**State of West Virginia
 Solicitation Response**

Proc Folder : 414207
Solicitation Description : Addendum No. 2
Proc Type : Central Purchase Order

The West Virginia Purchasing Division is soliciting bids on behalf of the West Virginia State Rail Authority (SRA) to establish a contract for the following: Repairs to bridges along the South Branch Valley Railroad (SBVR) The Vendor shall furnish any incidental work, materials, labor, and equipment that are necessary to complete the Construction Services per the terms and conditions and specifications as attached.

**Addendum No. 2 – CRFQ RMA1800000007
Questions and Answers**

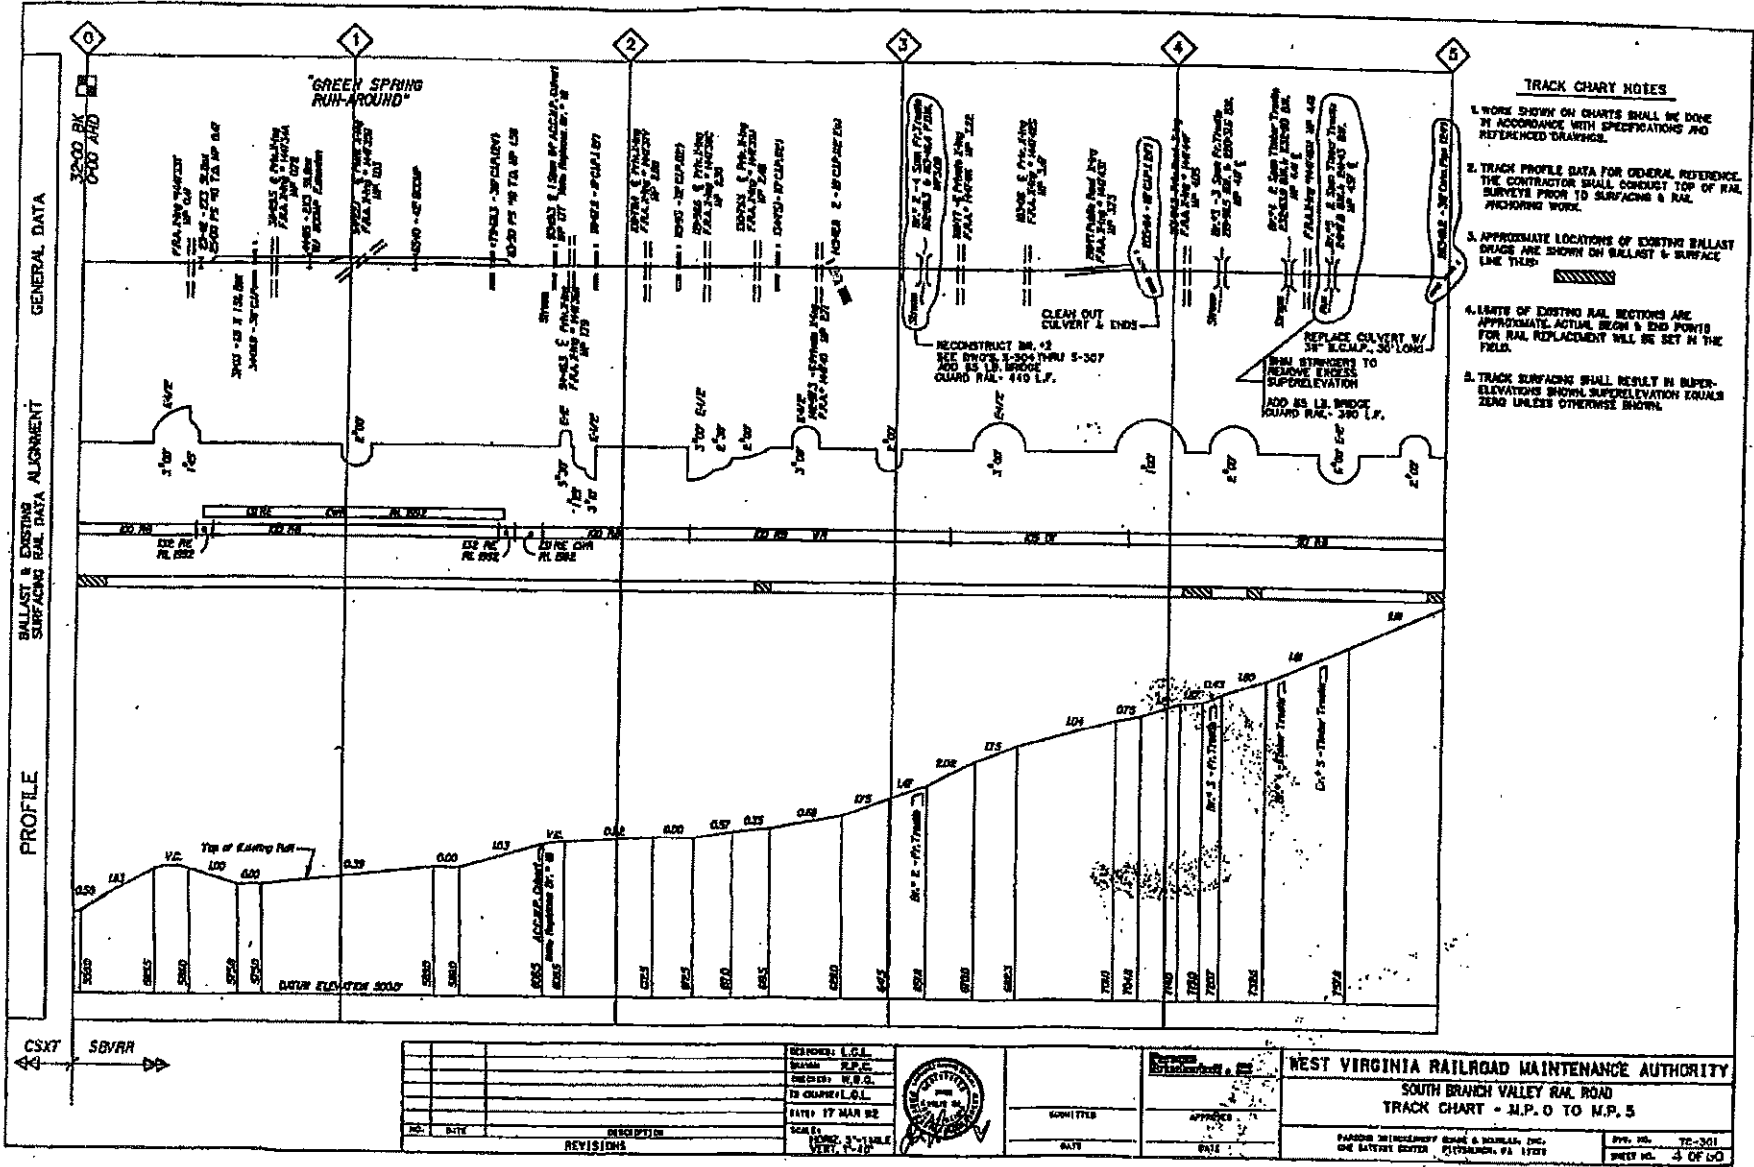
Q21. In 13.1.5.2 BR 23.2, the requirement of the 2 new end piers, are these to be constructed using Timber or Concrete?

Q22. Do you have any plans, specs or drawings for what you are wanting for end piers on BR 23.2?

Q32. BR 23.2 – Has any design work been completed for the concrete pier extensions? How will the new concrete attach to the existing? Rebar, details etc

Q33. RFQ document/form line 7, BR 23.2, the plans show details for the gabion baskets, what are the details for the new end piers? Also, the work scope in Exhibit B differs from the RFQ document/form?

A21. Timber in kind will be used. Refer to the drawing in Attachment A. Since only two piers will be remaining, contractor will add X bracing, pier to pair.

A22. Refer to answer 21

A32. Refer to answer 21 – Concrete will not be used

A33. For piers refer to answer 21 –
Exhibit B is the detail of scope, RFQ line item is a brief description

TRACK CHARTS

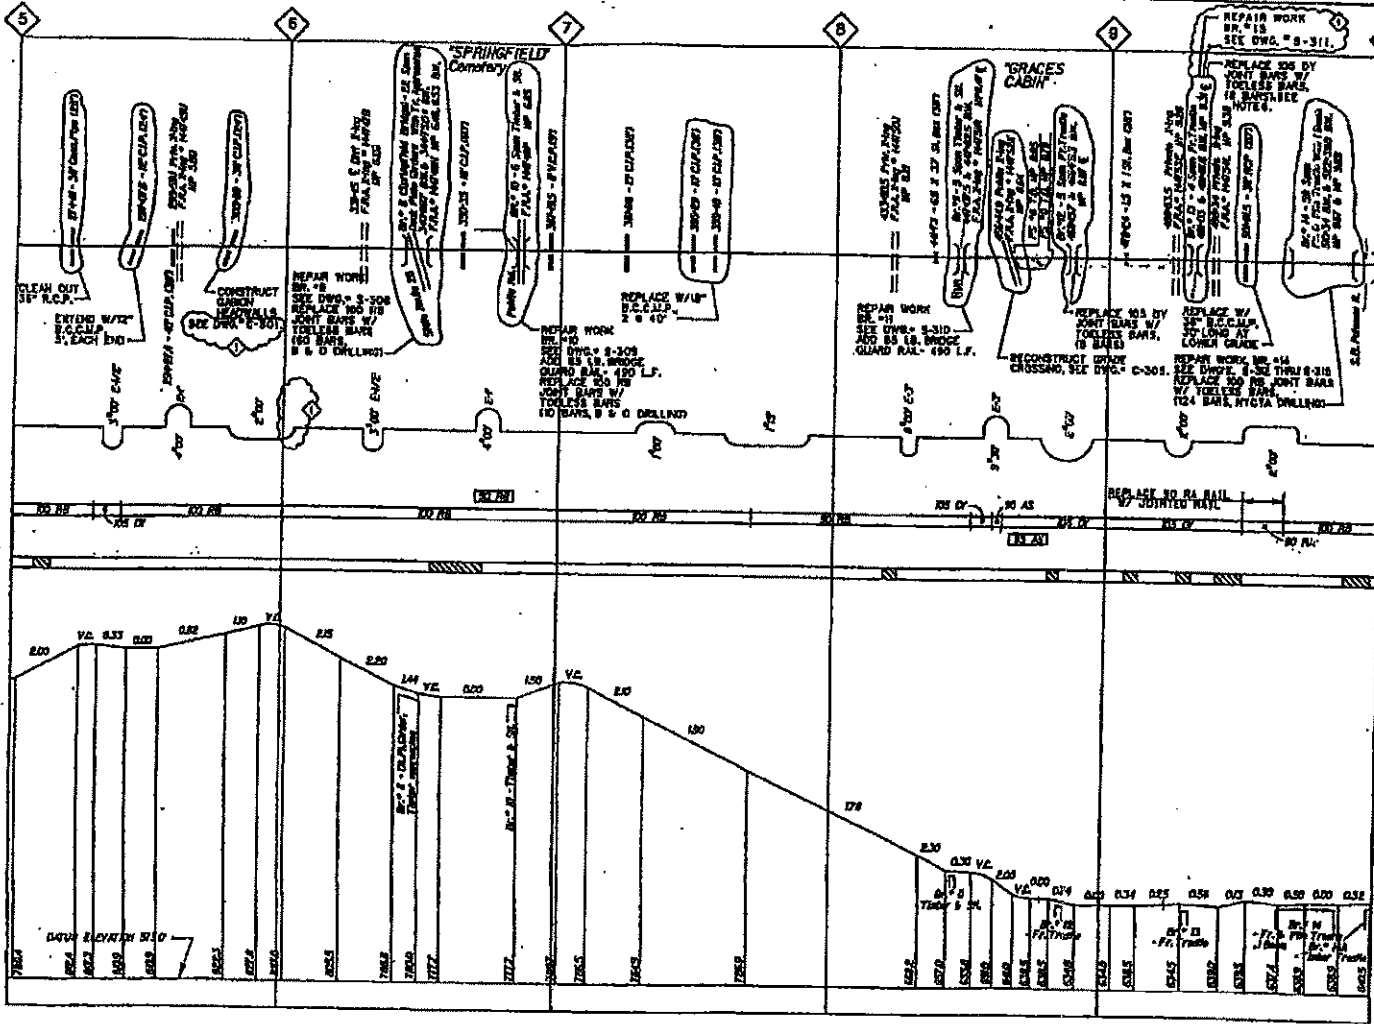
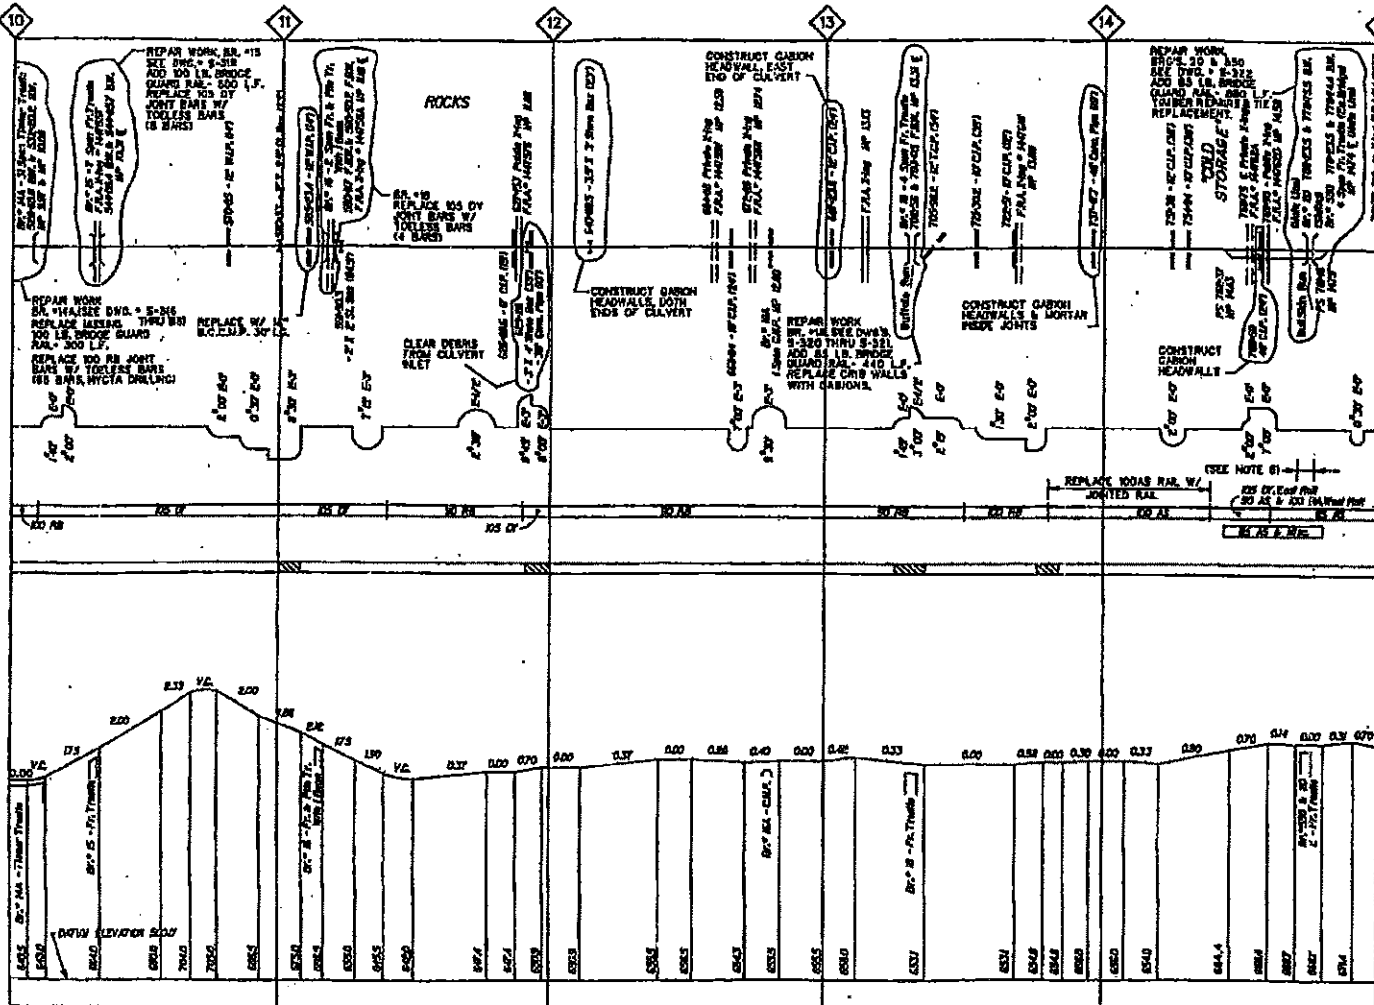
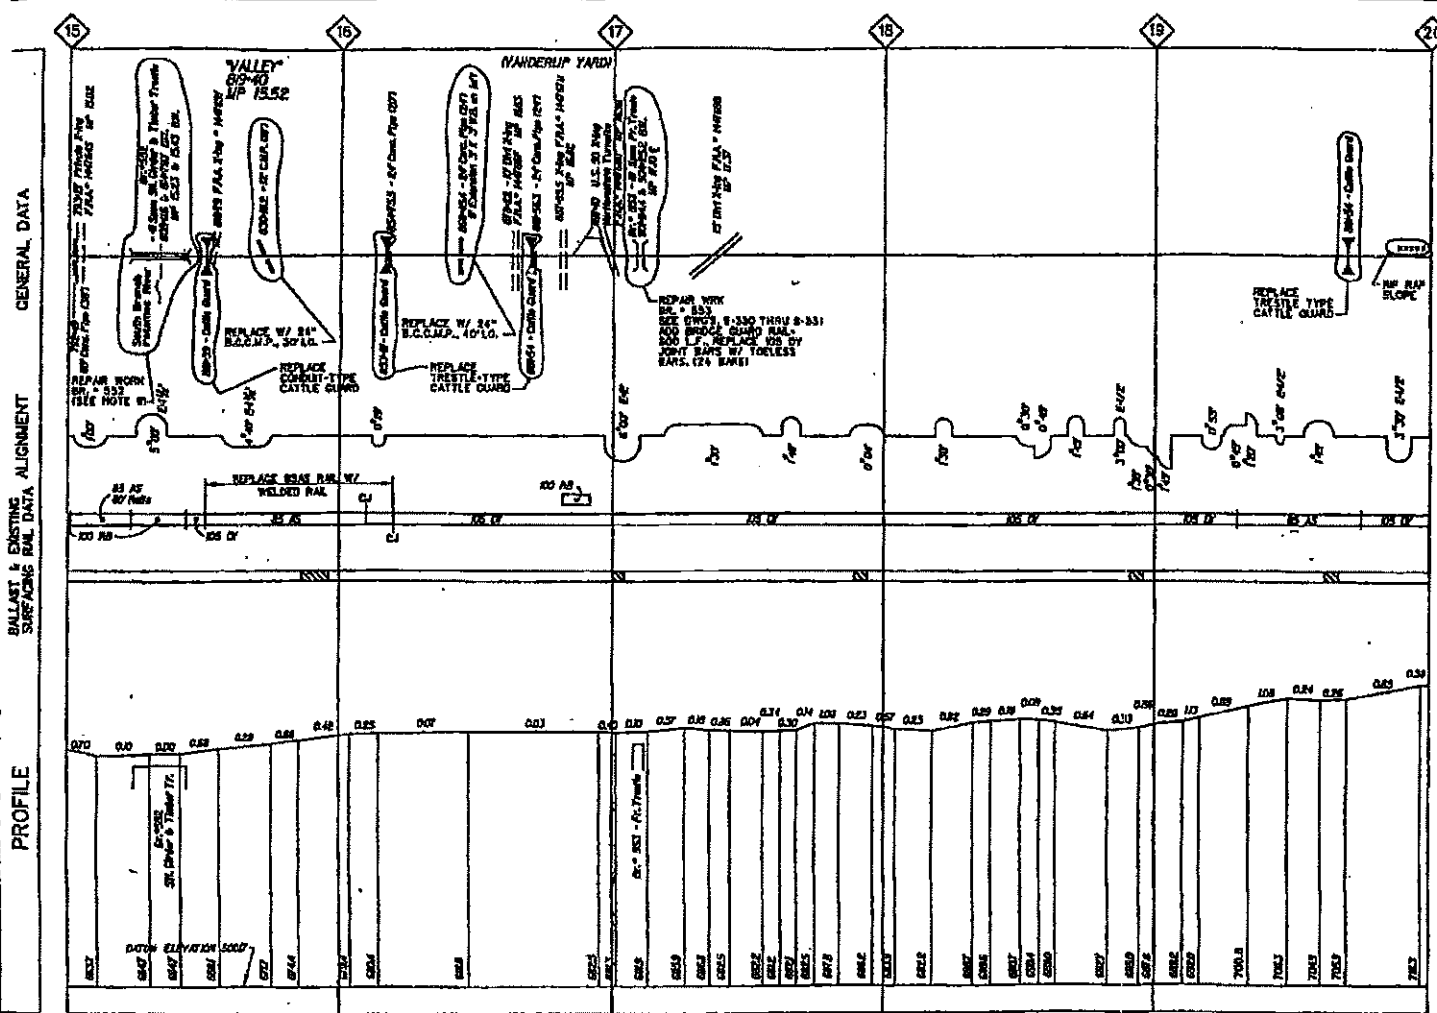
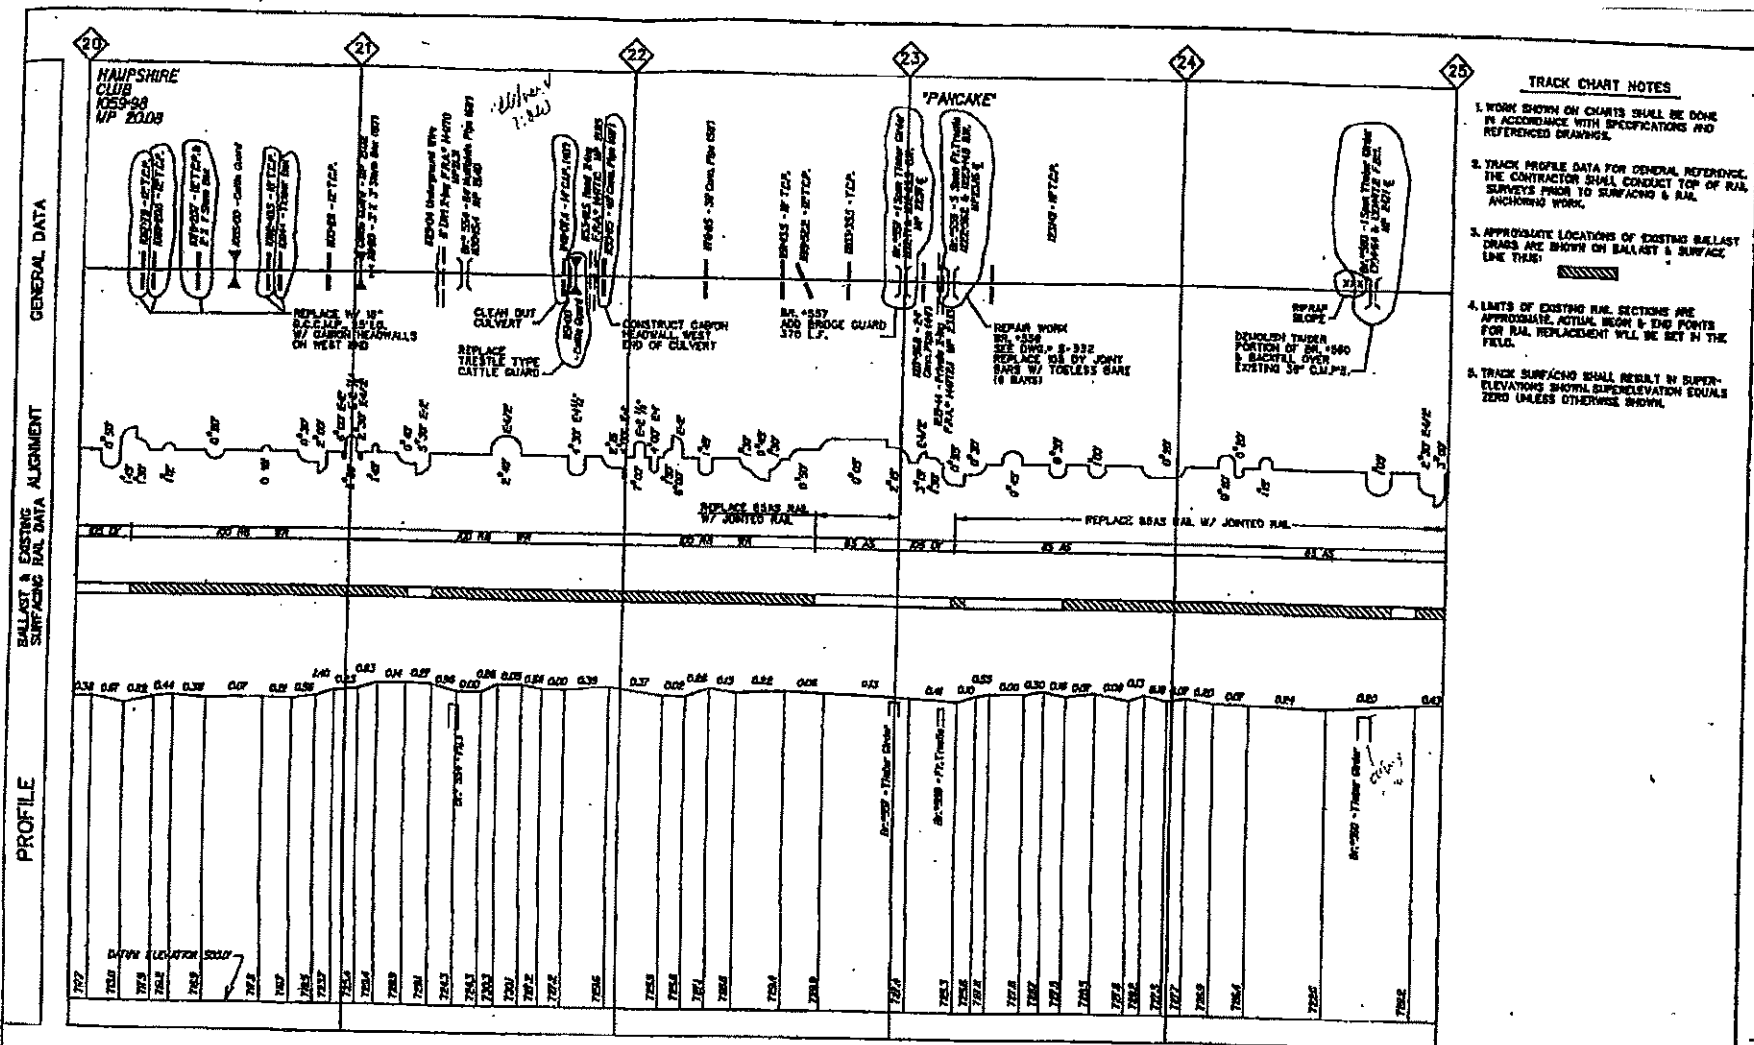
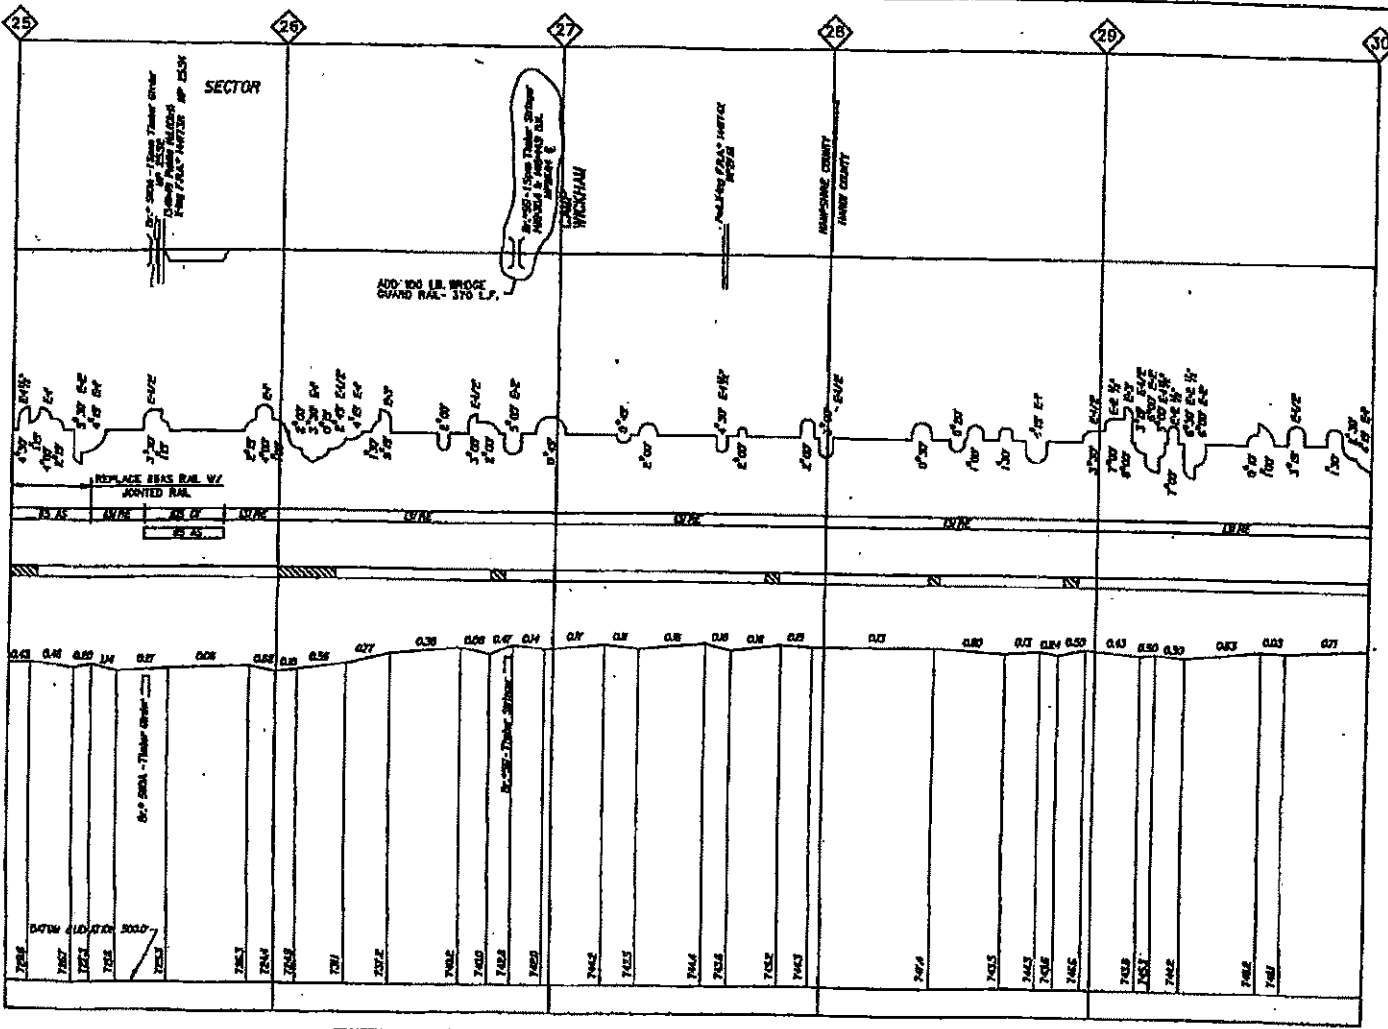
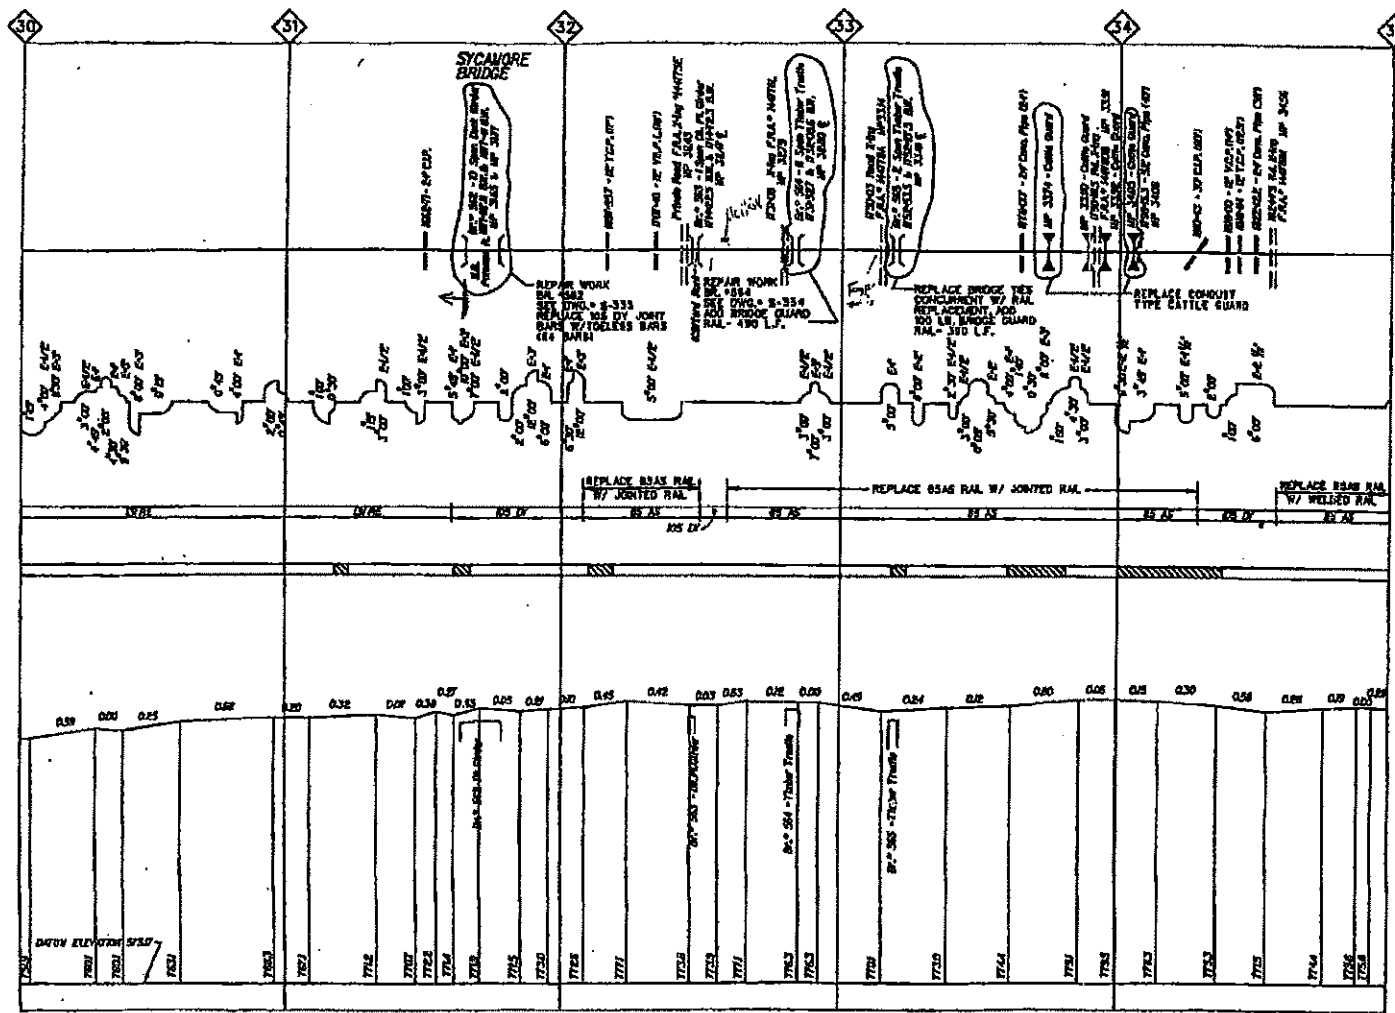
Q7. Can a copy of the track chart/profile extending 1 mile beyond each end of the milepost project limits be provided?

A7. Yes - Attached
